5921 Cedar Parkway, Chevy Chase
[HPc Case No. 35113-104]
Chevy Chase Village Historic District

STAFF ITEM

SUBJECT: Revision to approved HAWP (Case 35/13-104) for fencing and hardscape alterations at 5921 Cedar Parkway, Chevy Chase, a **Contributing Resource within the Chevy Chase Historic District**

DATE: February 22, 2011

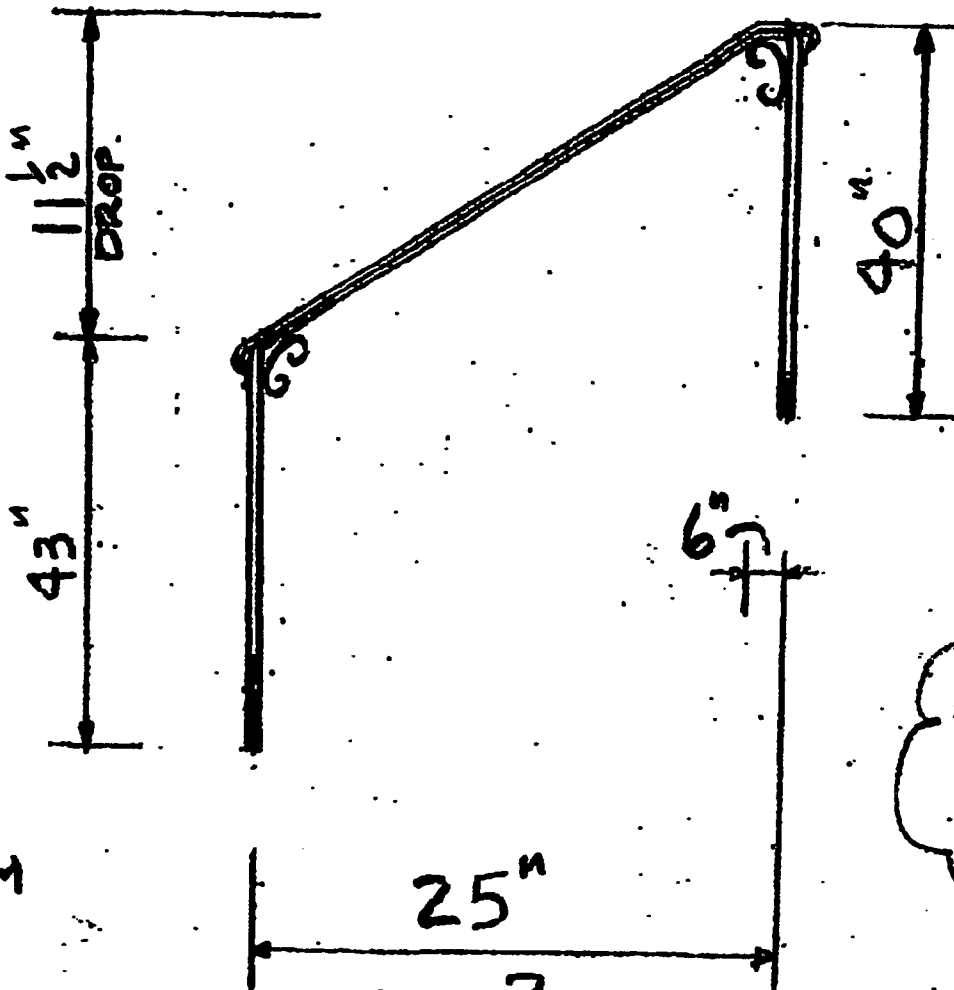
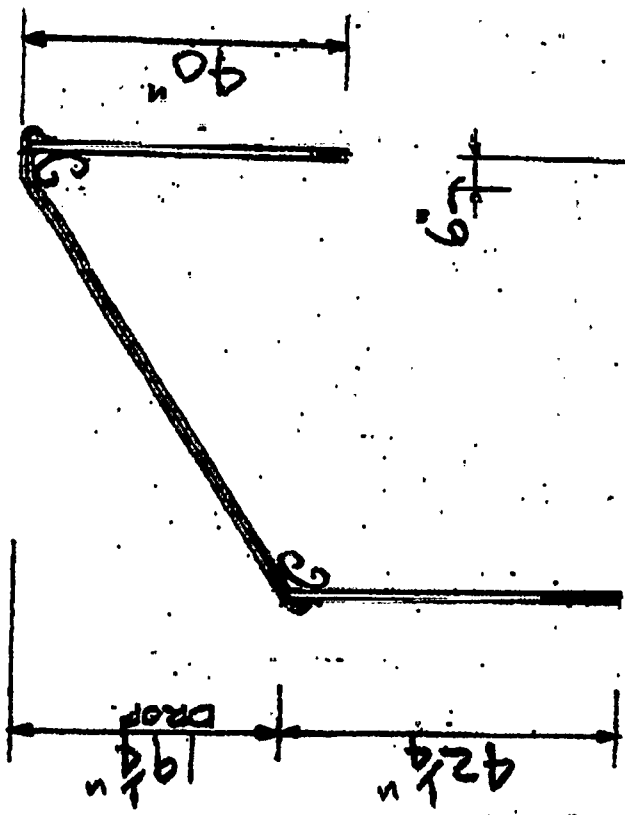
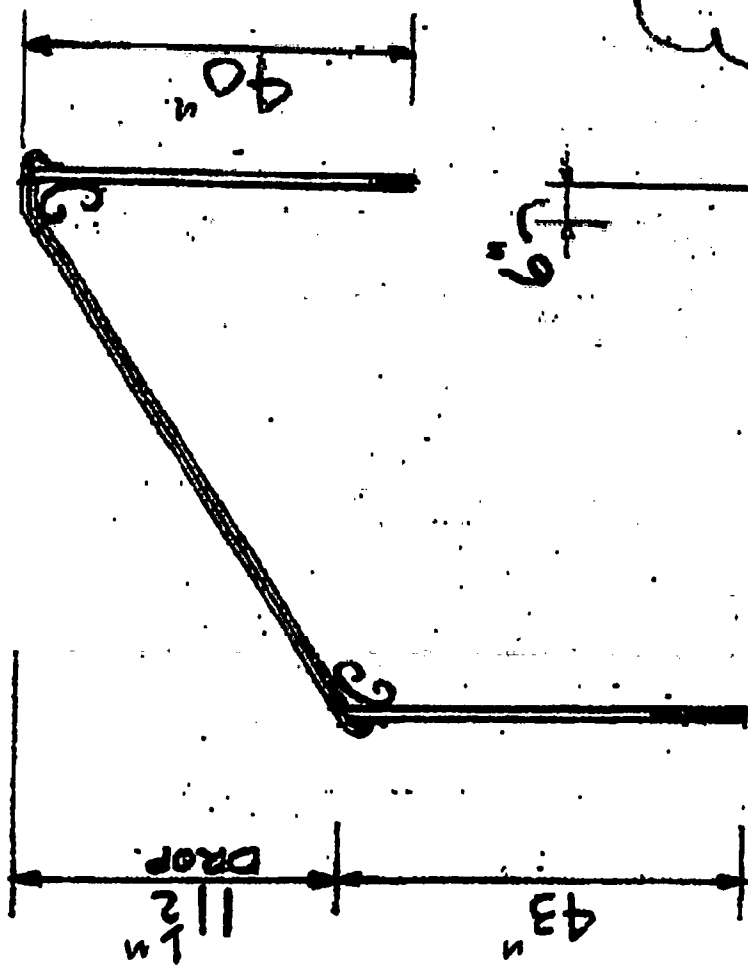
REVISED PROPOSAL: Install two sets of wrought iron railings on both sides of the front concrete steps.

BELGIUM
L1 x 1/2
BELGIUM

"C" SCROLLS

1" POST SIDES
 REQ'D - 8 -
 SEND LOOSE - BLACK

STAFF RECOMMENDATION: Staff is recommending that the HPC approve this change.
